Dakota Springs Engineering

PPR-18-053

**RE: Lot 3, Beckett at Woodmen Hills, Filing No. 3
El Paso County, CO
Drainage Letter**

PROJECT **BECKETT AT WOODMEN HILLS**
 SHEET TITLE **GRADING AND DRAINAGE PLAN**
 FROM _____ TO _____
 JOB NO. **6742451** SHEET **1** OF **1**

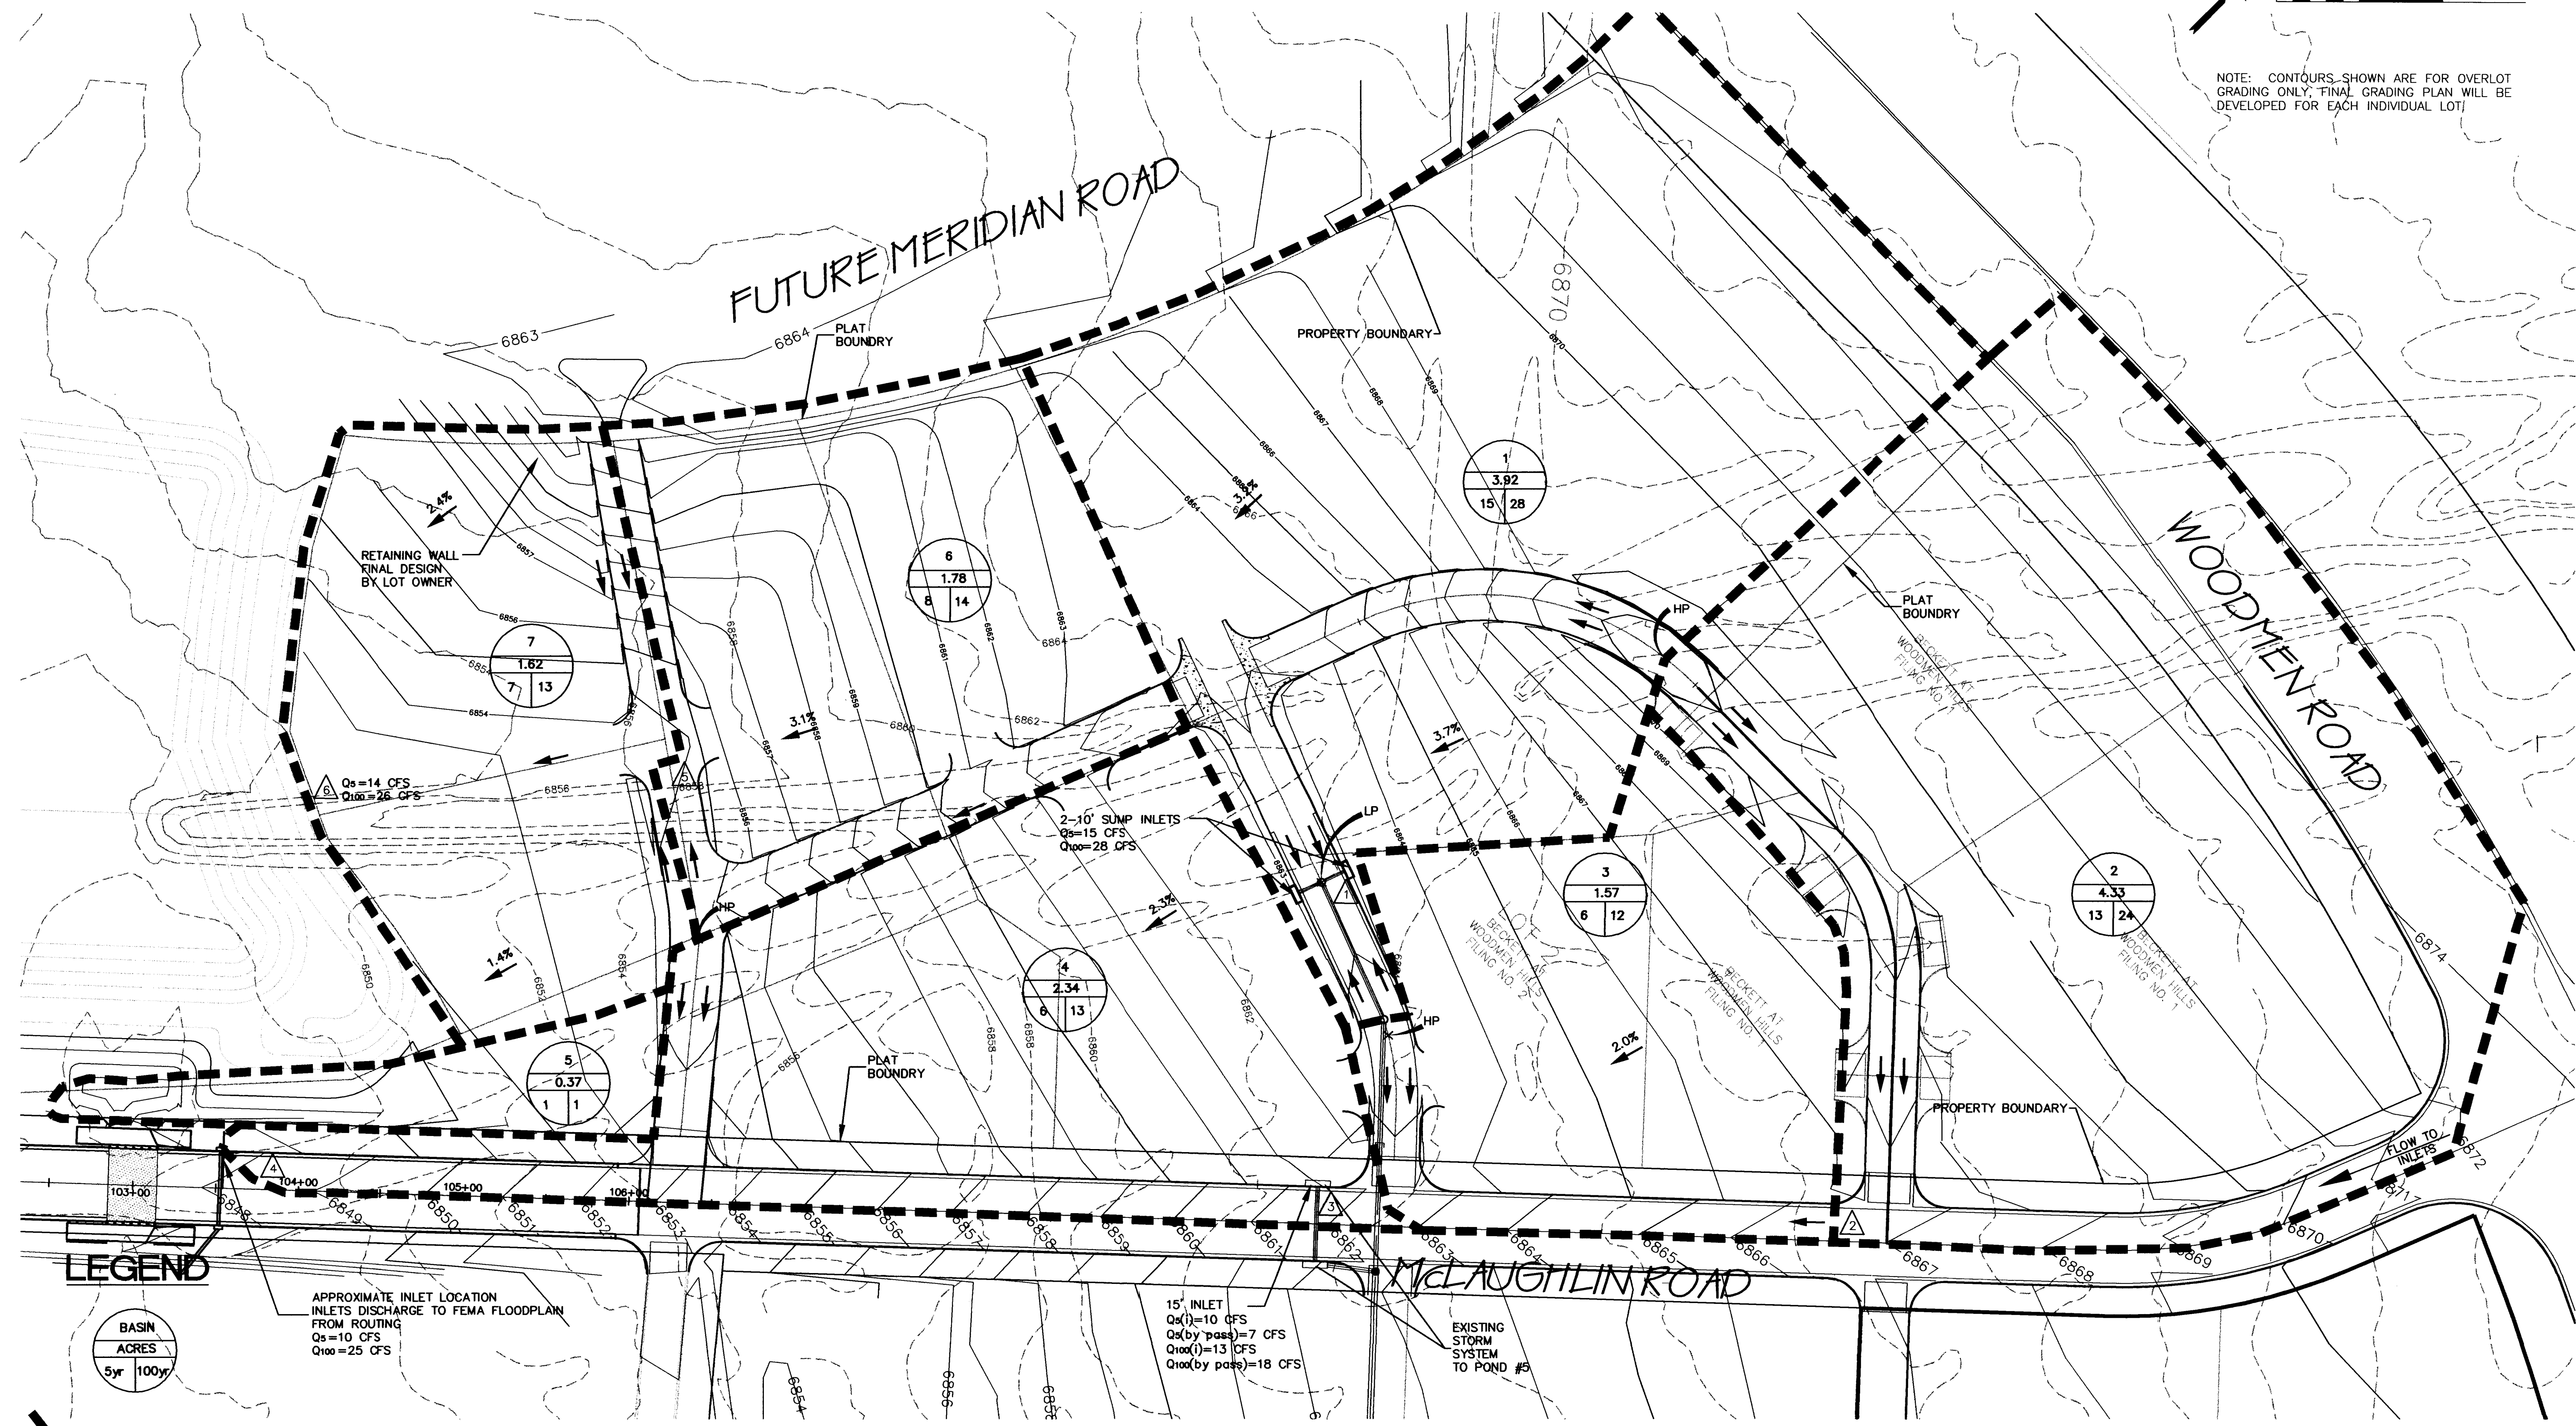
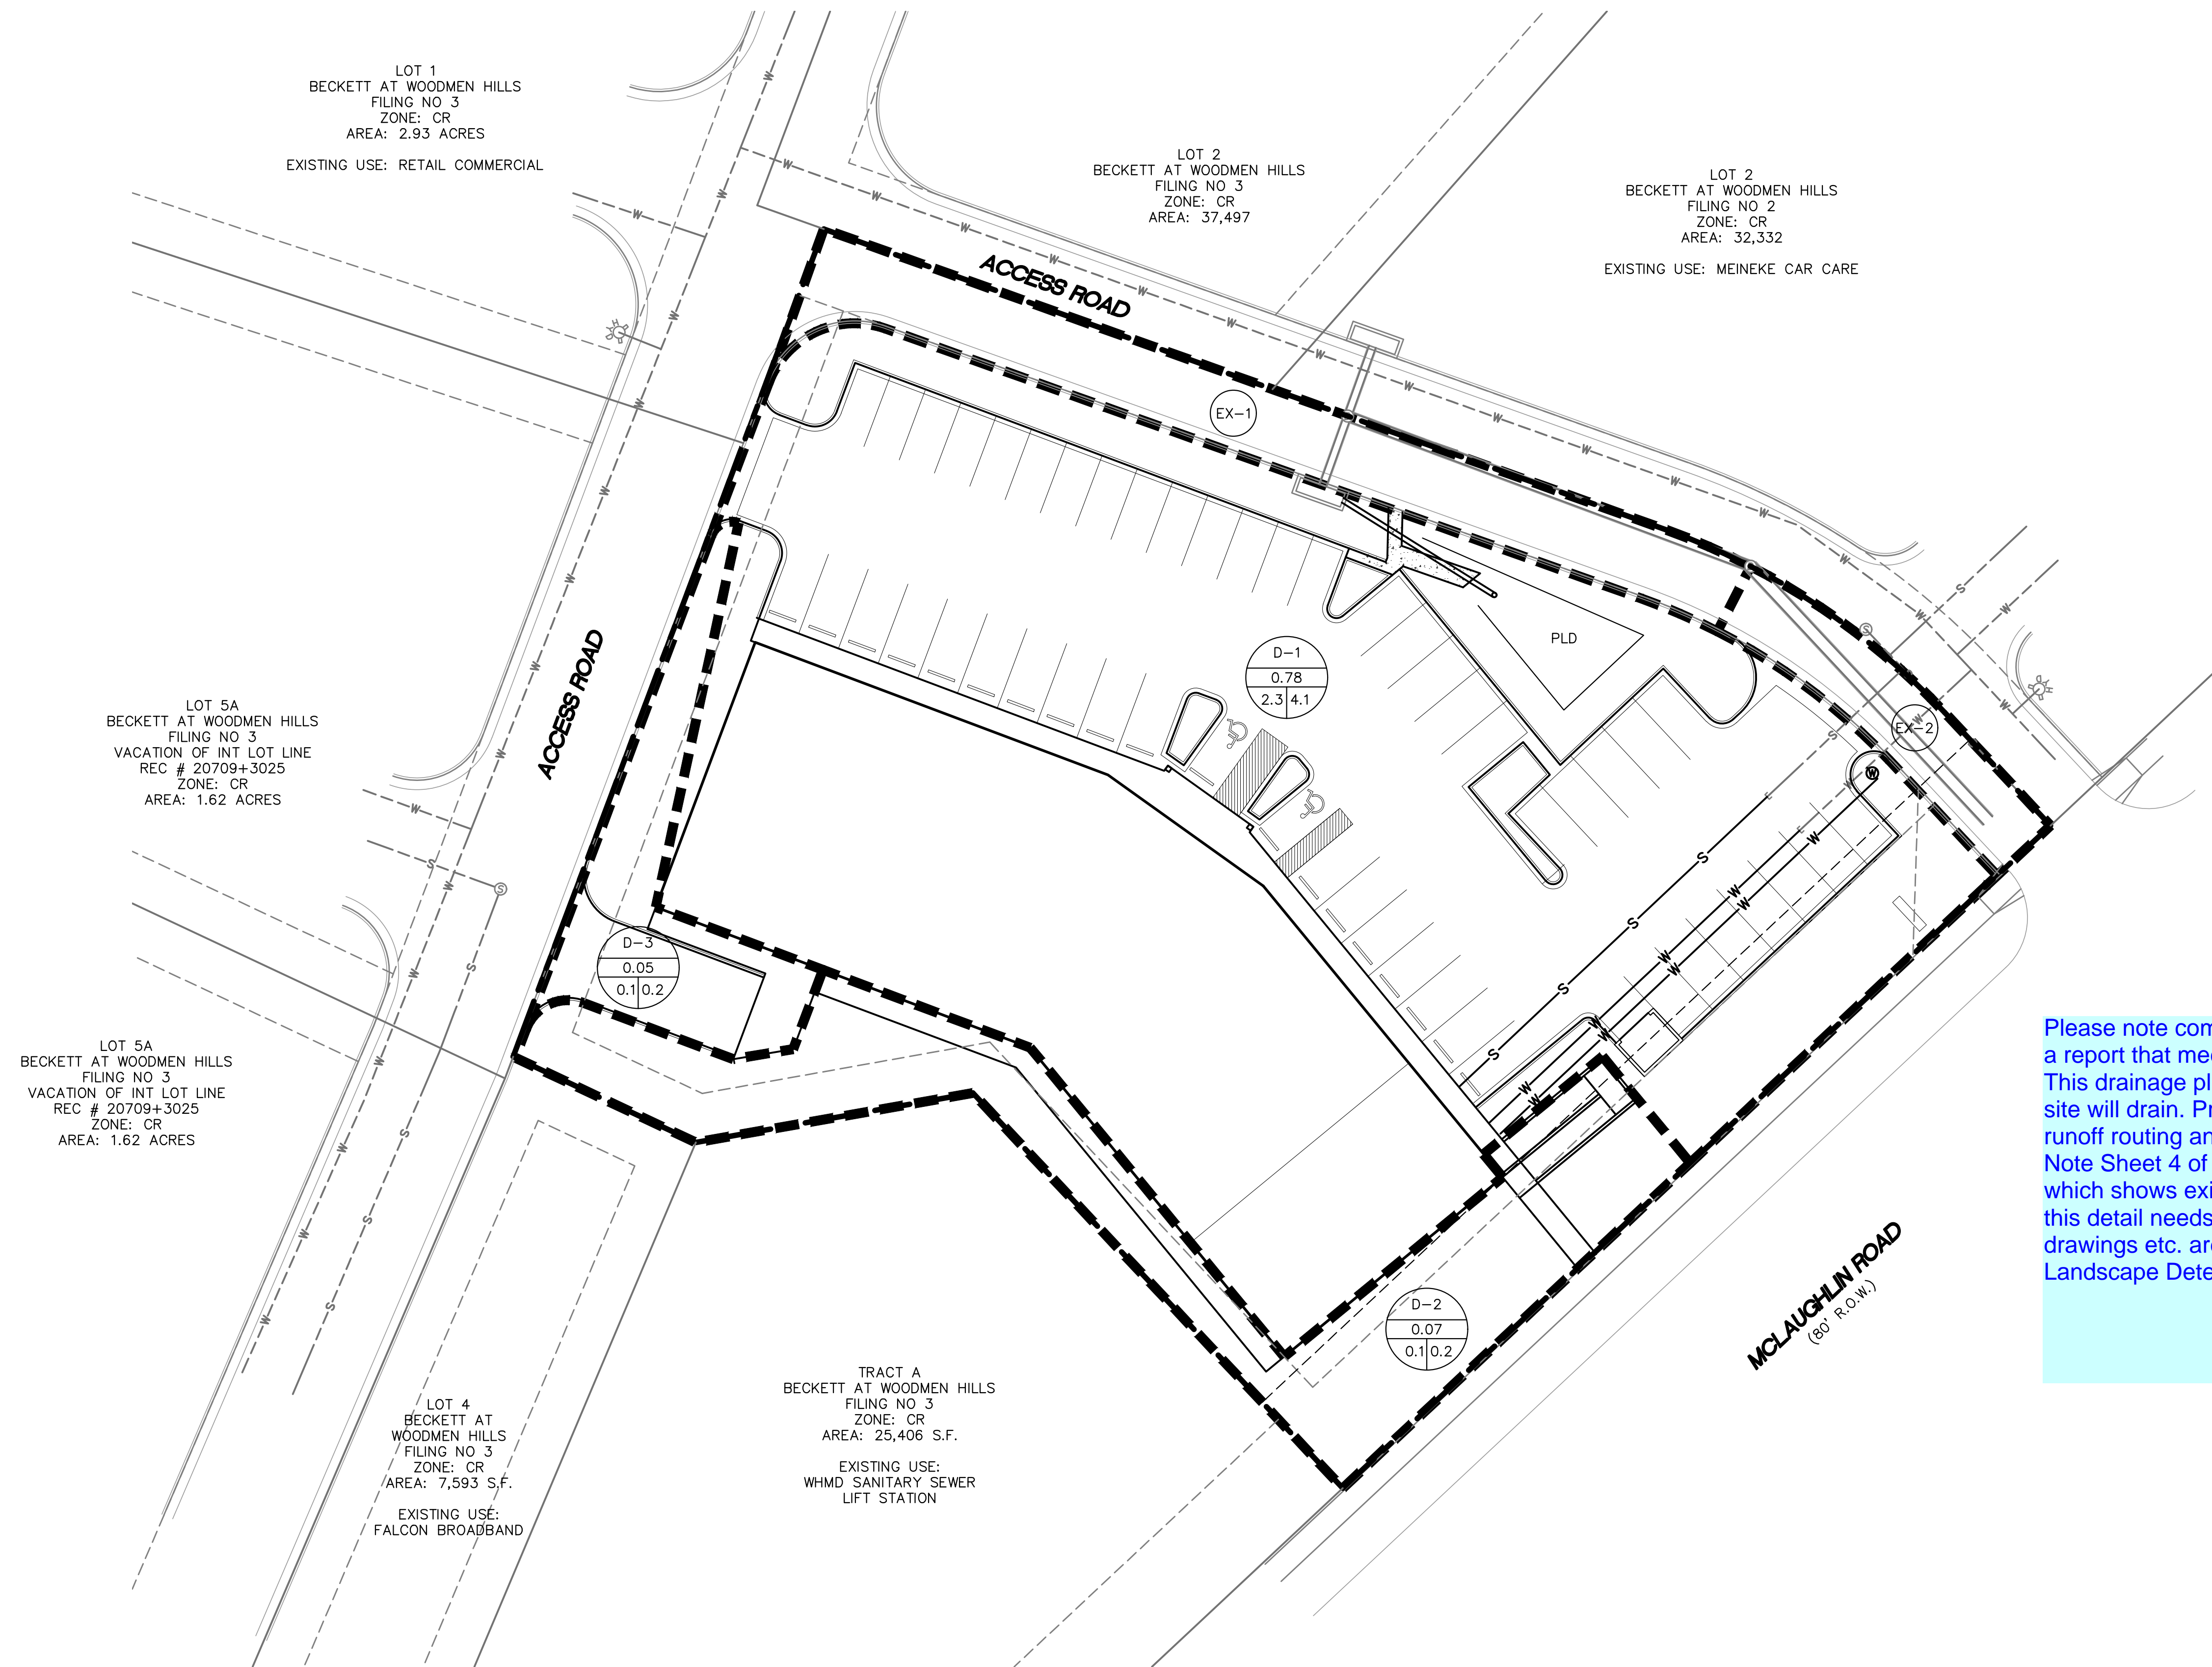
Identify in the report where 5 and 100 year detention is provided for, is this facility constructed and accepts flow from this project.

PROPOSED BASIN MAP

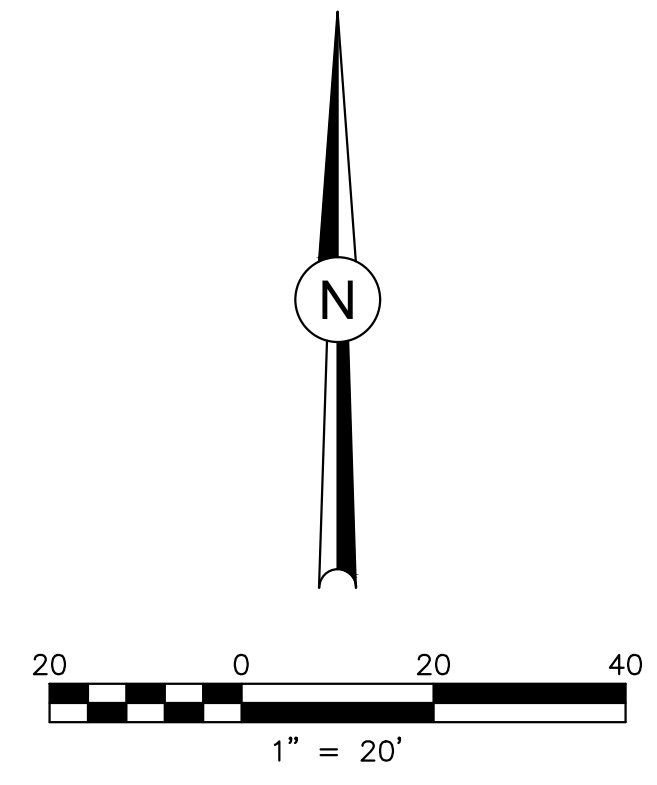
Please note comment version one review. Provide a report that meets criteria. This drainage plan/map needs to indicate how the site will drain. Provide contours. Indicate storm runoff routing and rates, etc. Note Sheet 4 of 6 of the site development plan, which shows existing and final contours. a plan of this detail needs to be provided. Calculations drawings etc. are needed to support the Porous Landscape Detention facility.
